FED. ROAD DIST. NO.	STATE	FED. AID PROJ. NO.	FISCAL YEAR	SHEET NO.	TOTAL SHEETS
HAWAII	HAW.	HSIP-011-2(37)	2009	ADD. 6	34

STATE OF HAWAII  
DEPARTMENT OF TRANSPORTATION  
HIGHWAYS DIVISION  
**TYPICAL SECTIONS**  
MAMALAOA HIGHWAY  
SAFETY IMPROVEMENTS  
Vicinity of Kiolakaa Homestead Road  
Federal-Aid Project No. HSIP-011-2(37)

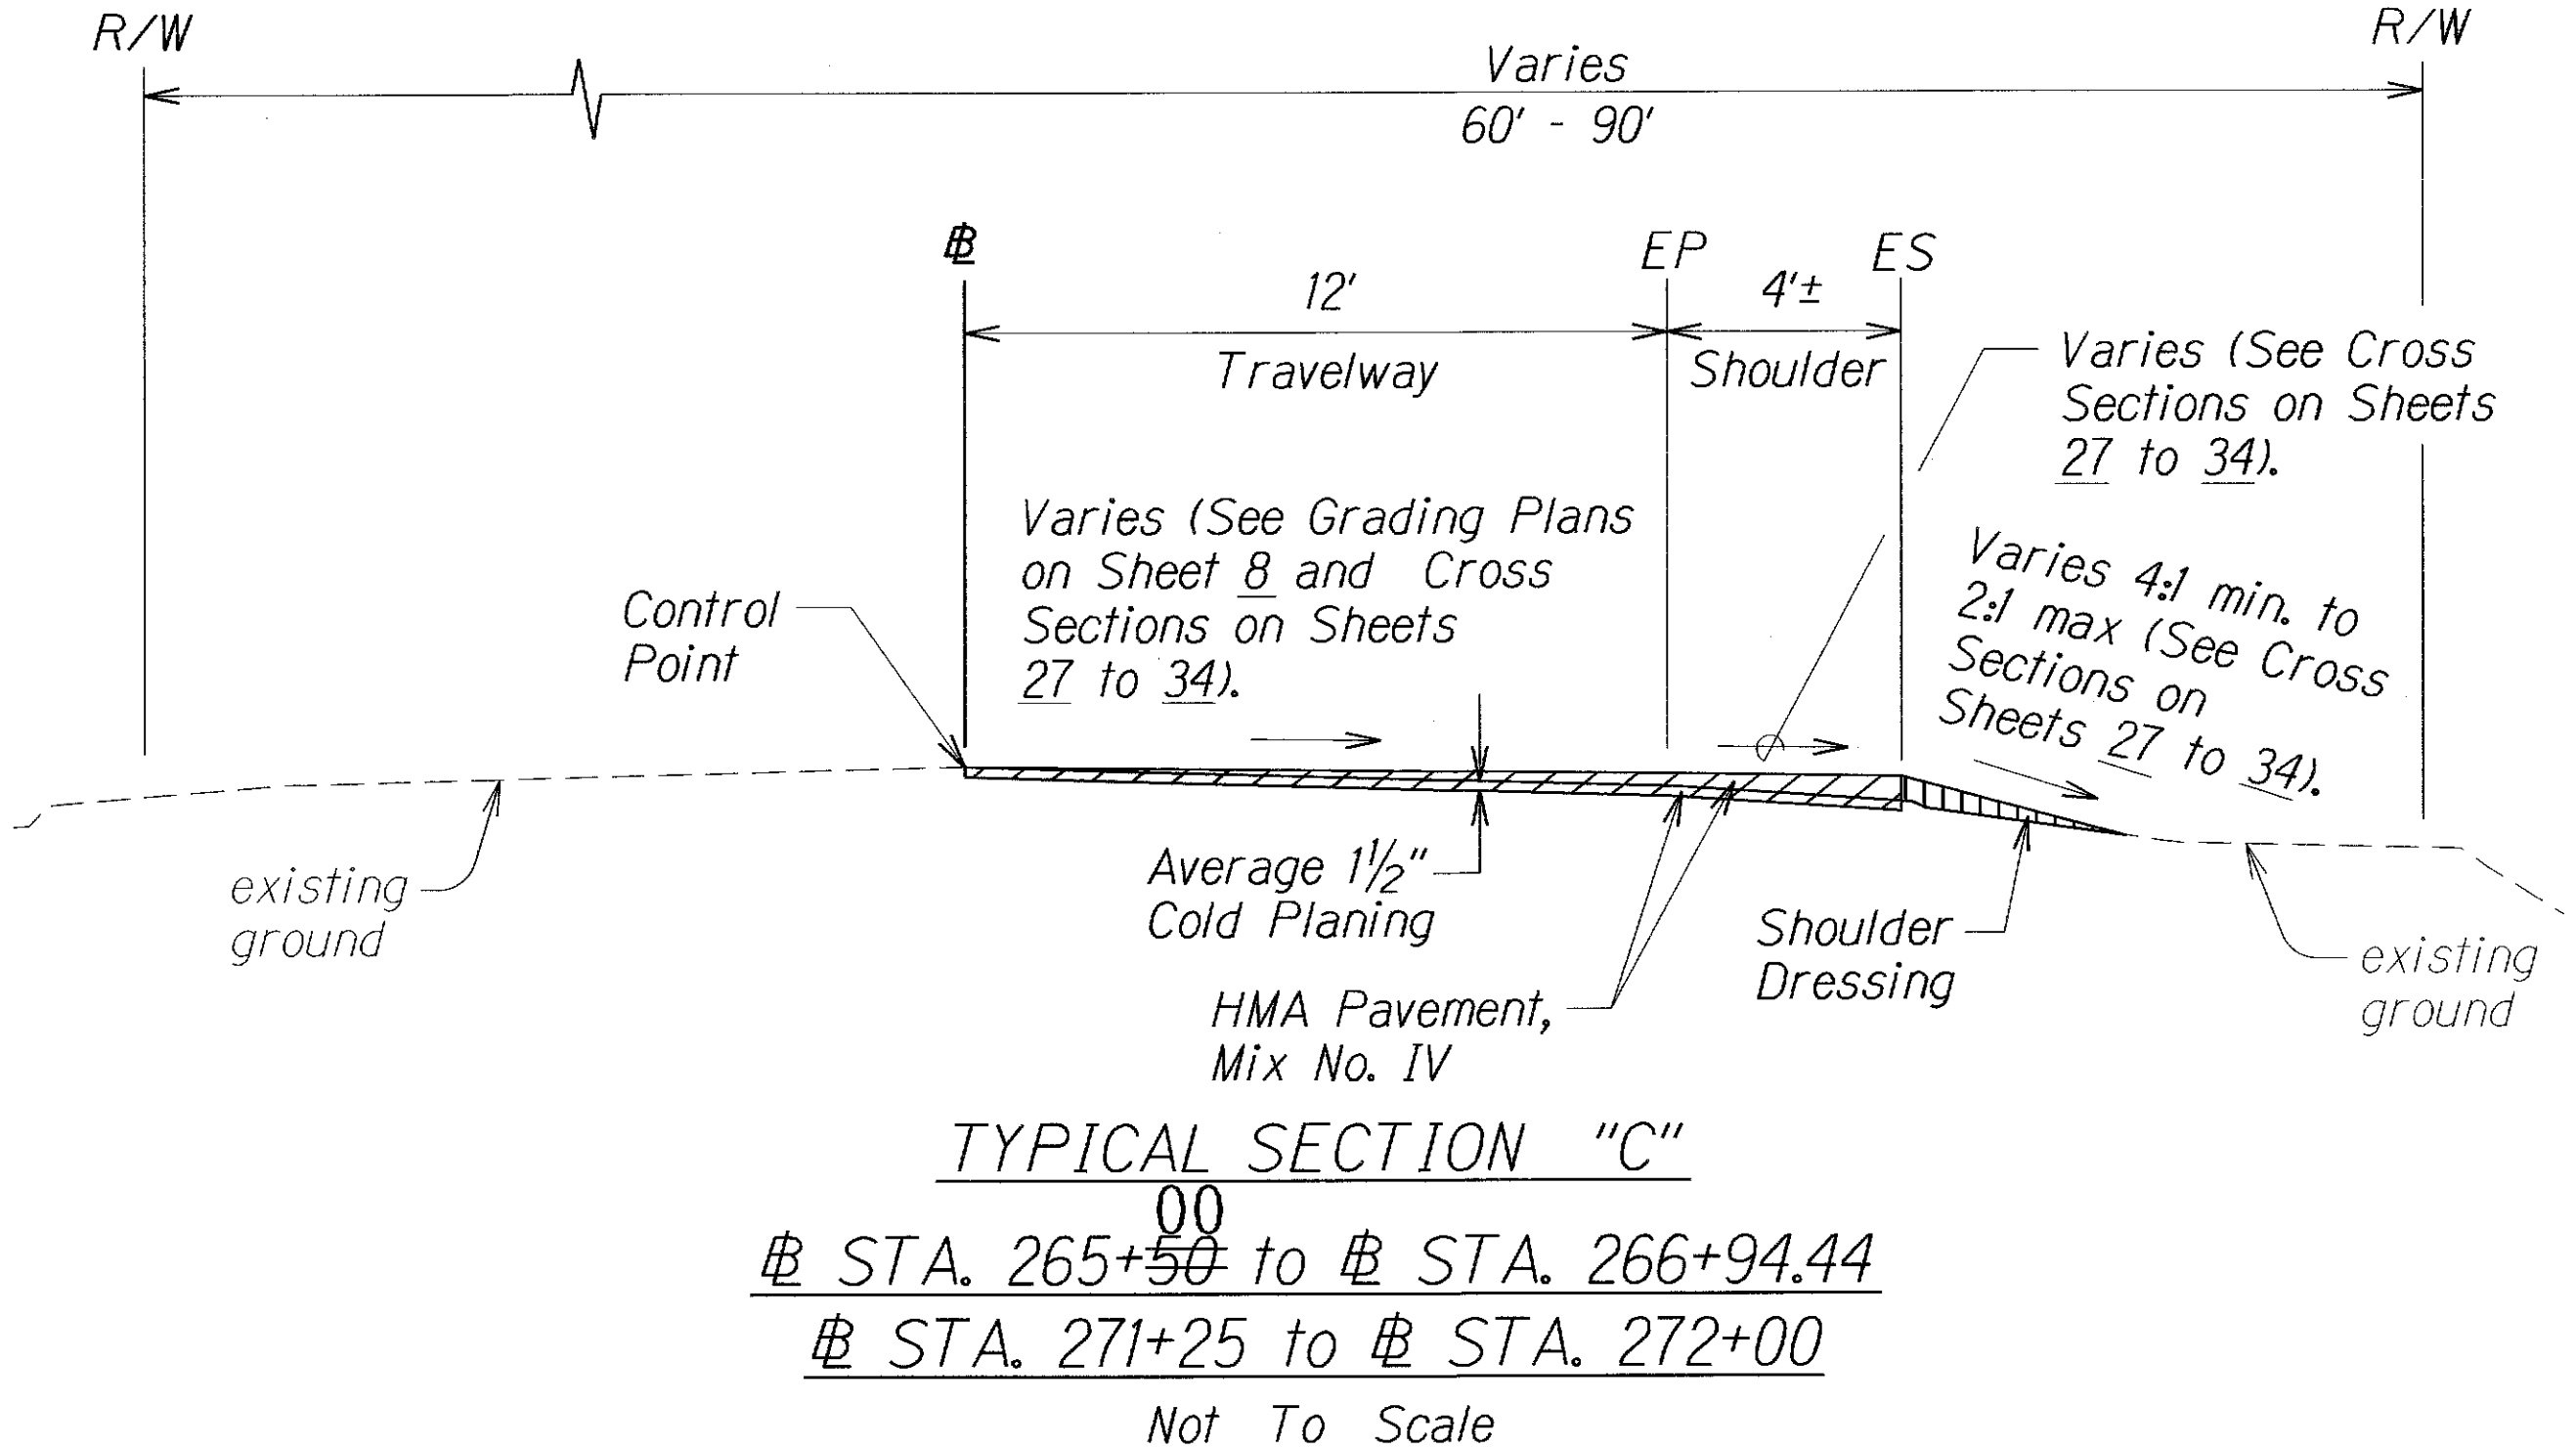
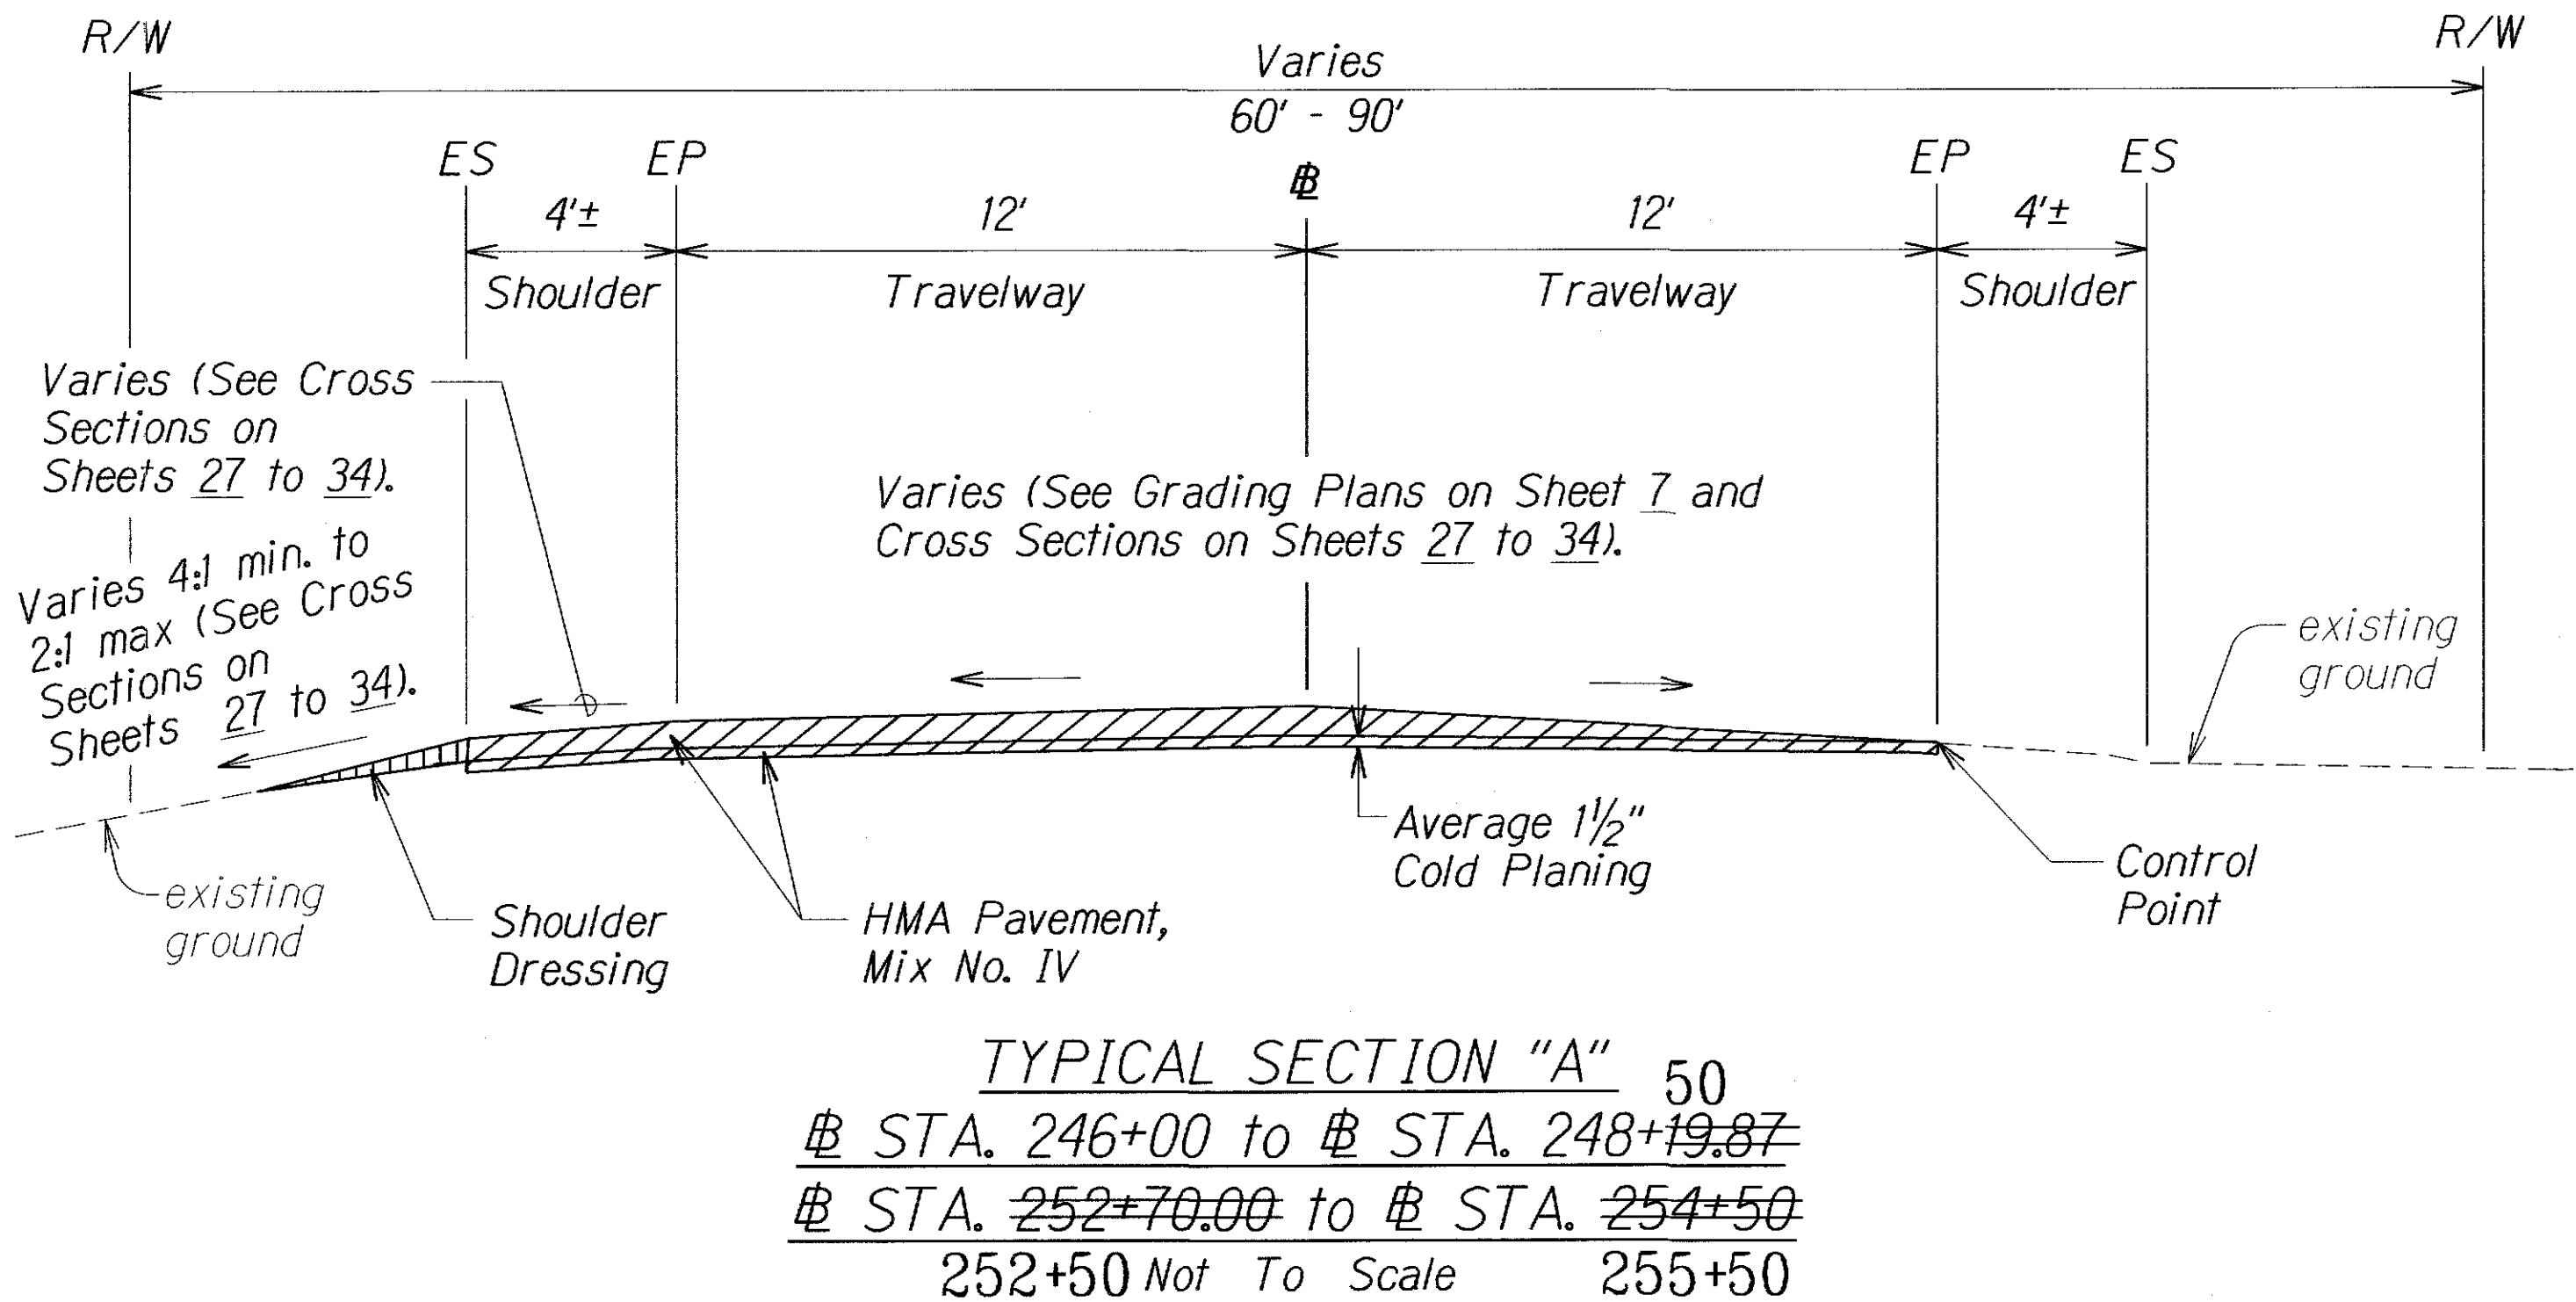
9/15/09	Added Notes. Revised Shoulder Slope. Revised Stationing for each Typical Section.
DATE	REVISION

- Shoulder dressing shall be considered incidental to Item No. 401.0100 - HMA Pavement, Mix No. IV.
- The Contractor shall provide and maintain a smooth transition with no drop offs between travel lanes during non-working hours. If pavement is not completed, a 6:1 wedge may be used for transition, at no increase in contract price or contract time.
- The Contractor must shield shoulder drop offs with Type II Barricades if exposed during non-working hours.
